**CLARKE COUNTY PLANNING COMMISSION
TABLE OF CONTENTS
August 29, 2017 Briefing Meeting
September 1, 2017 Regular Meeting**

**SPECIAL USE PERMIT/SITE PLAN (SUP-17-03/SP-17-01)
Clarke County Board of Supervisors (Citizens' Convenience Center)
September 1, 2017 Planning Commission Meeting –PUBLIC HEARING
STAFF REPORT– Department of Planning**

CLARKE COUNTY CITIZEN CONVENIENCE CENTER CLARKE COUNTY, VIRGINIA

SHEET NO. C201

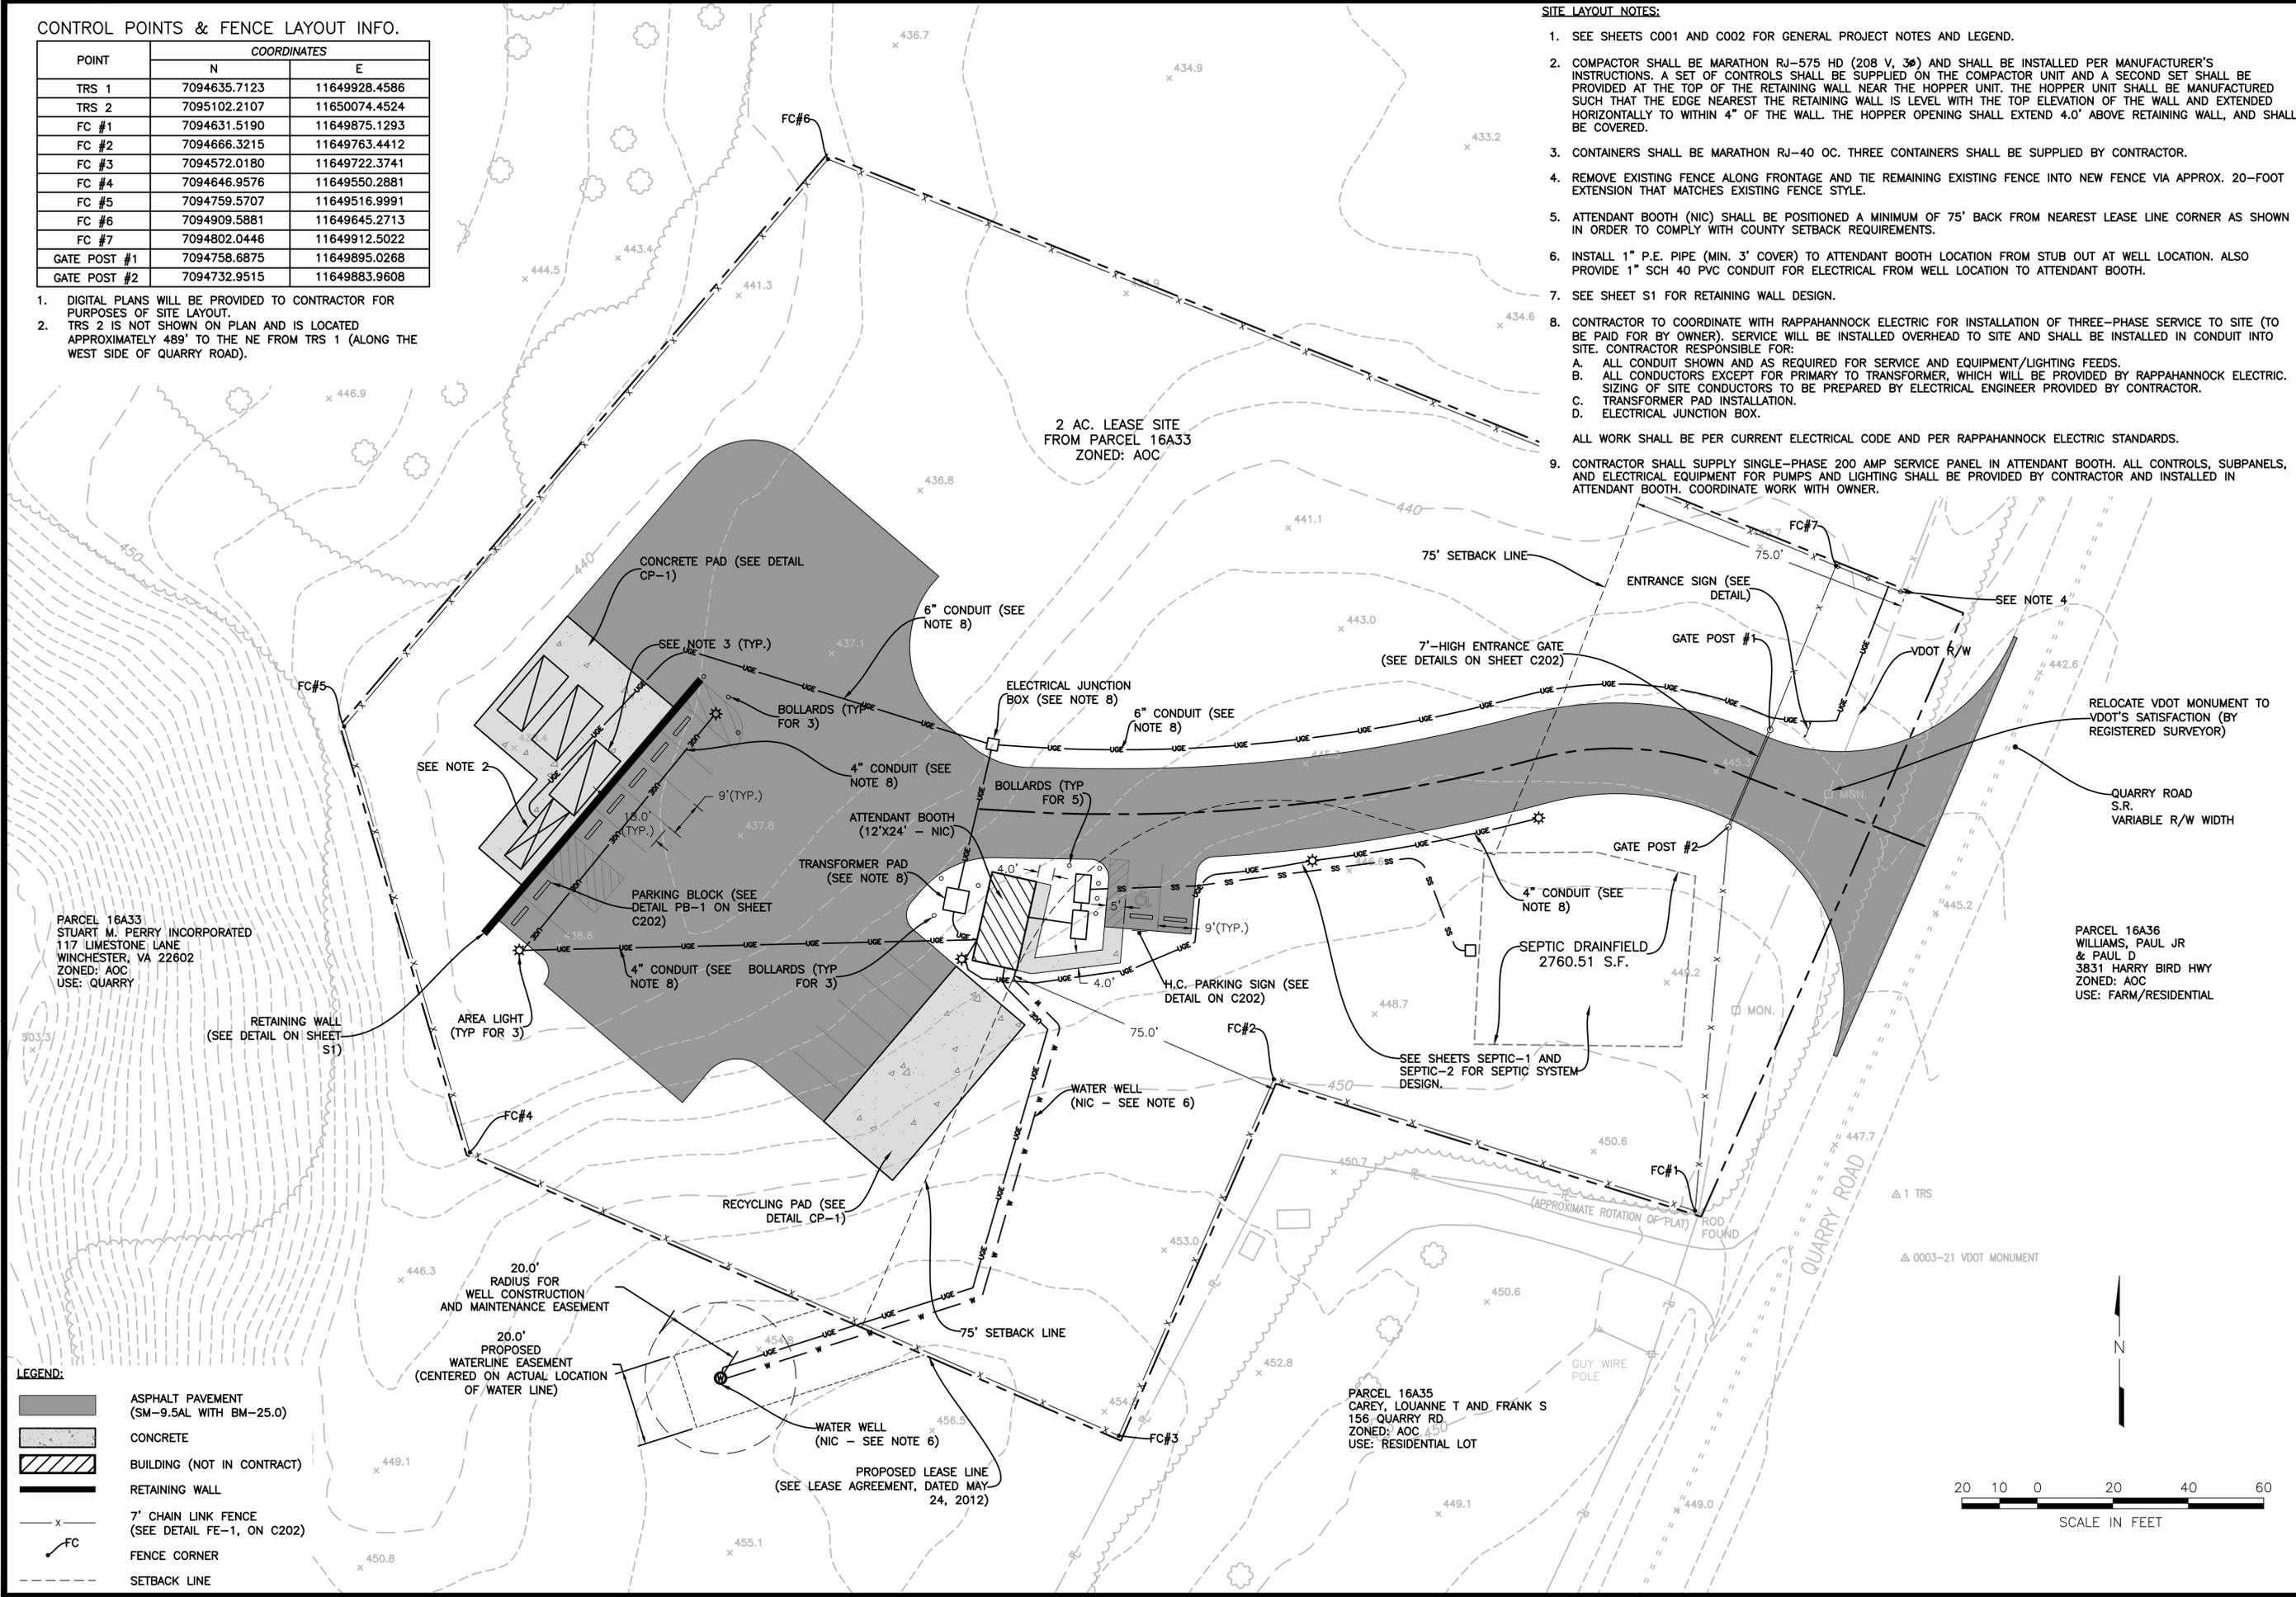
Update: Per Planning Commission recommendations, the landscaping plan has been revised to take out the non-native (Ginkgo) trees and have been replaced with suggested native species, flipped the location of the American Holly and the Inkberry within the 25' width vegetative buffer. Also, although not a requirement, the Blue Rug Junipers on the slope behind the recycling pad have been removed and this slope is to be seeded with grass. There was a comment about having a more refined planting grouping at the entrance. The engineer reported that there is not ample room between the fence and the right of way line for other than the required buffer plantings, and plantings were moved back to be sure they are out of the right of way per VDOT comment.

SHEET NO.
C501

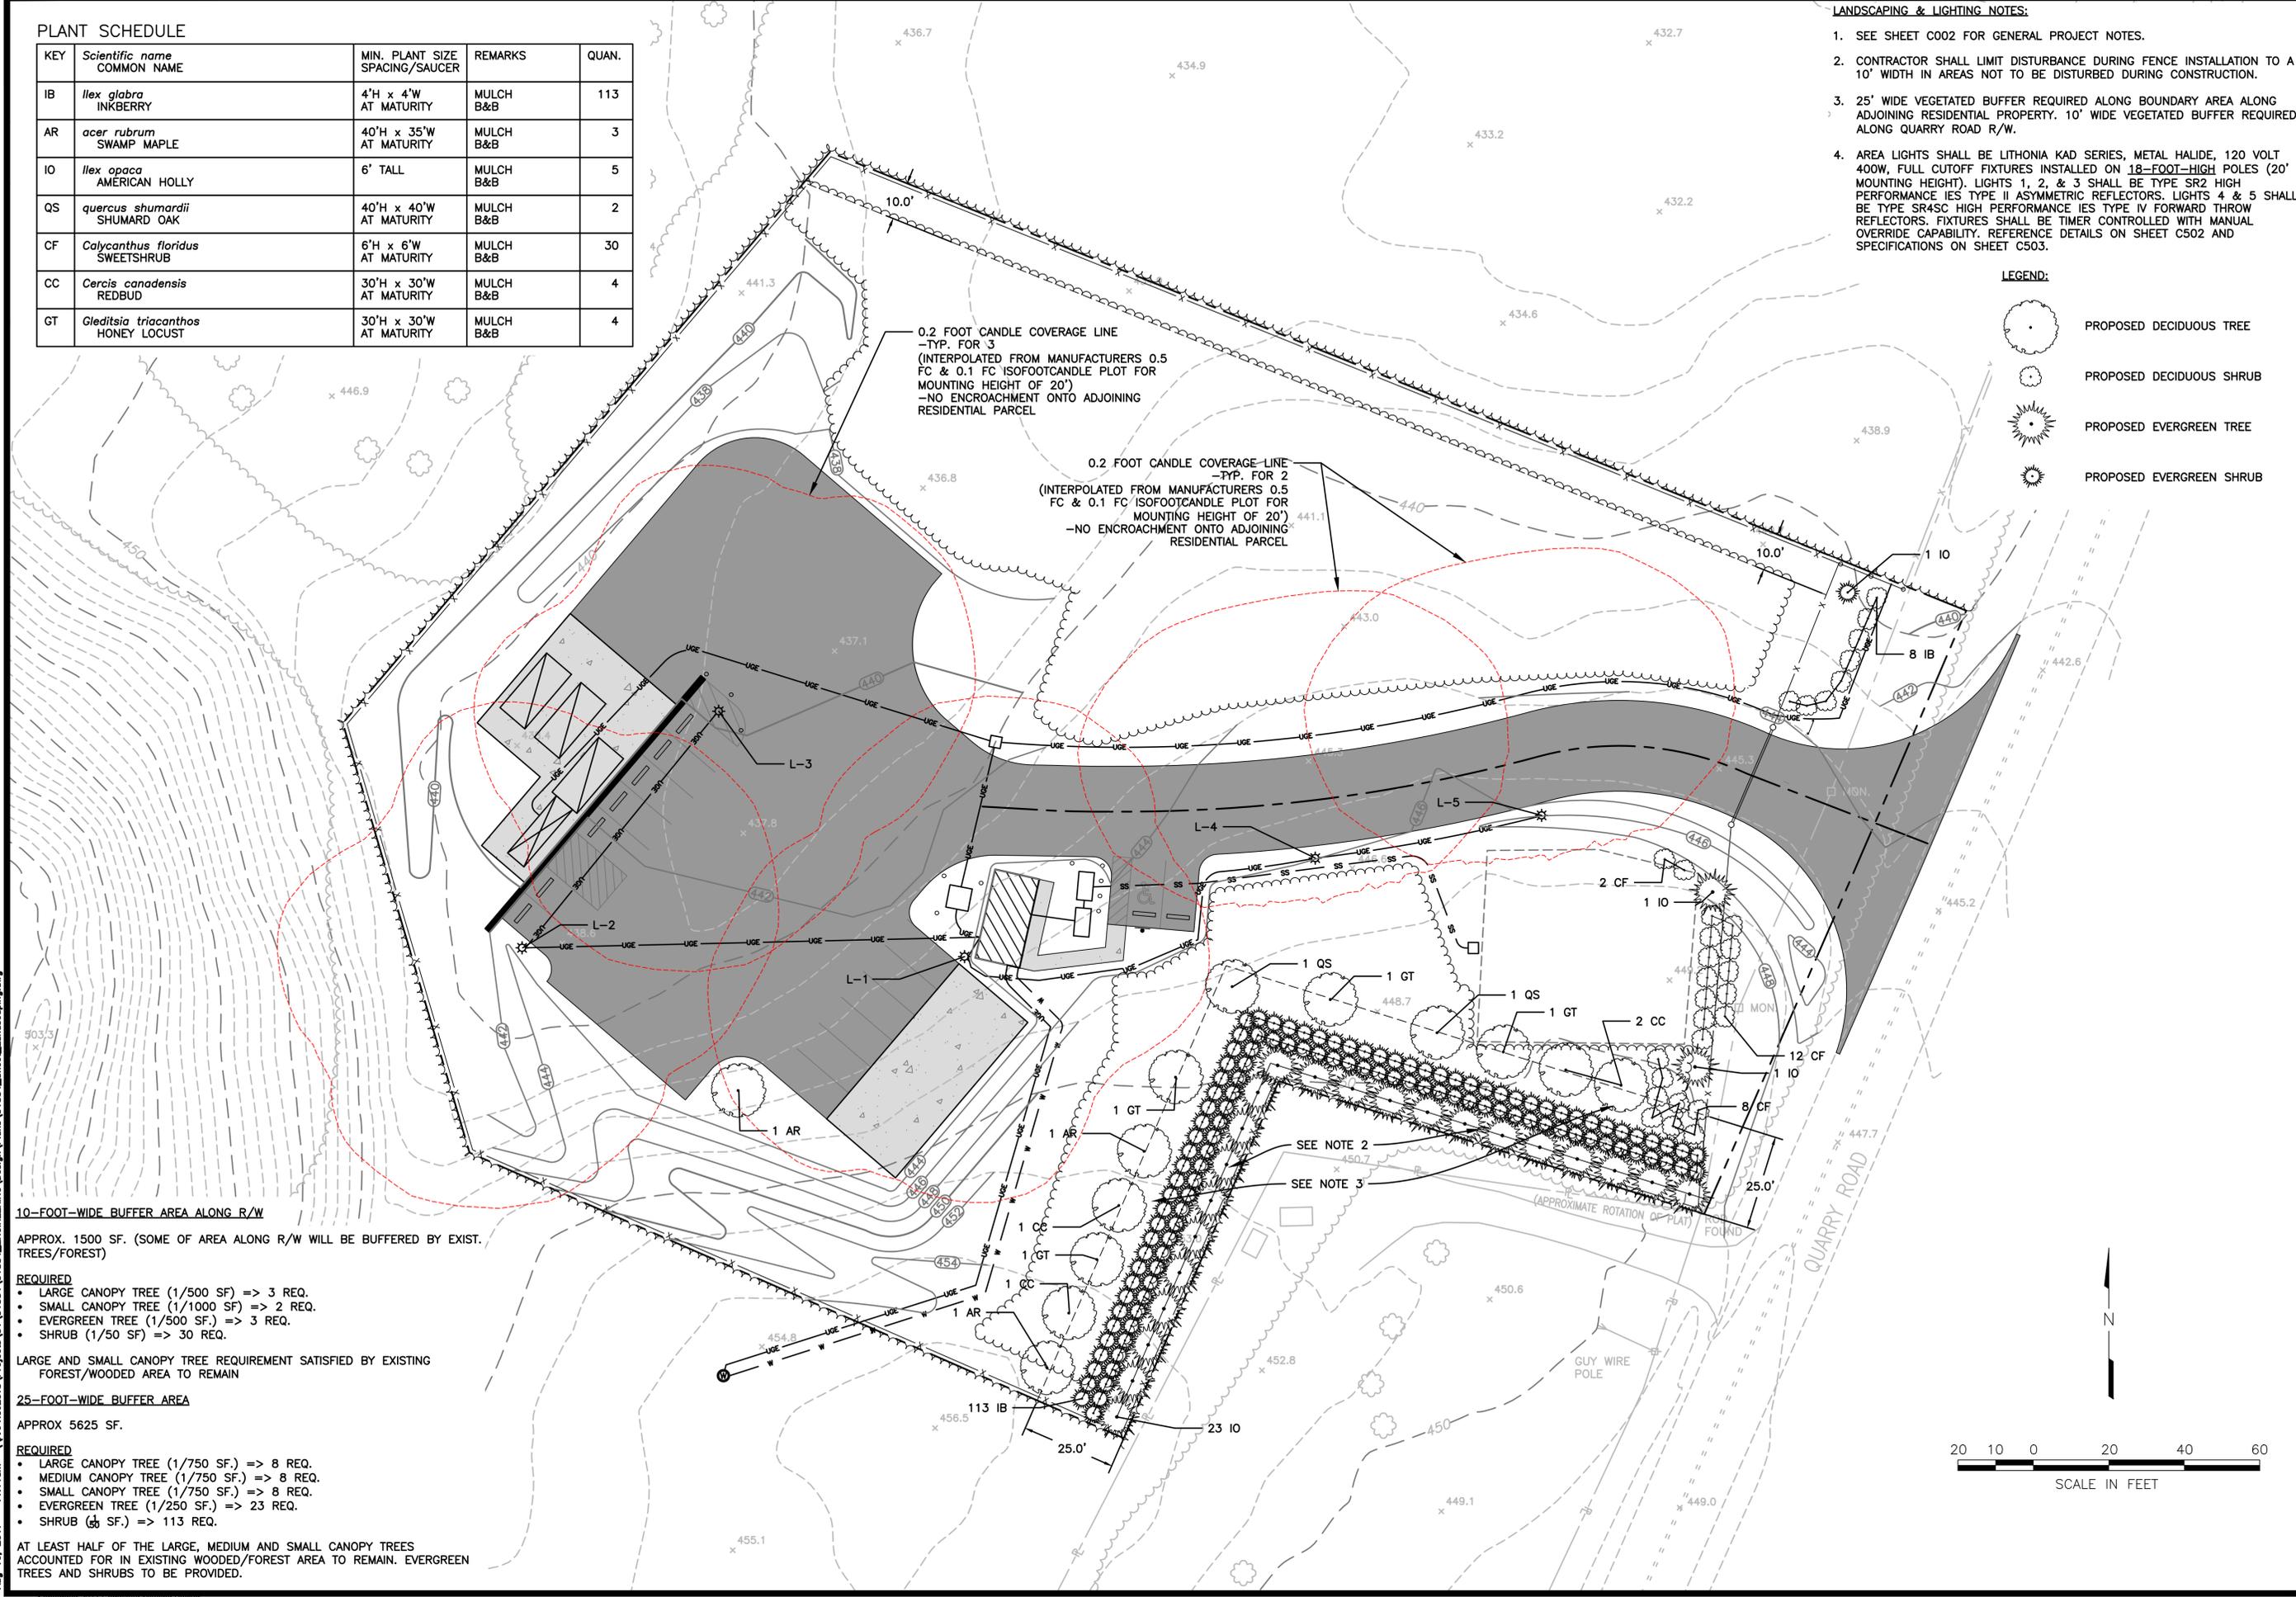
The initial plan indicated one species of tree that is prohibited, and the Agent will revise. The Plans Review Committee expressed interest in recommending alternative species for that replacement and perhaps some of the proposed shrubbery as well.
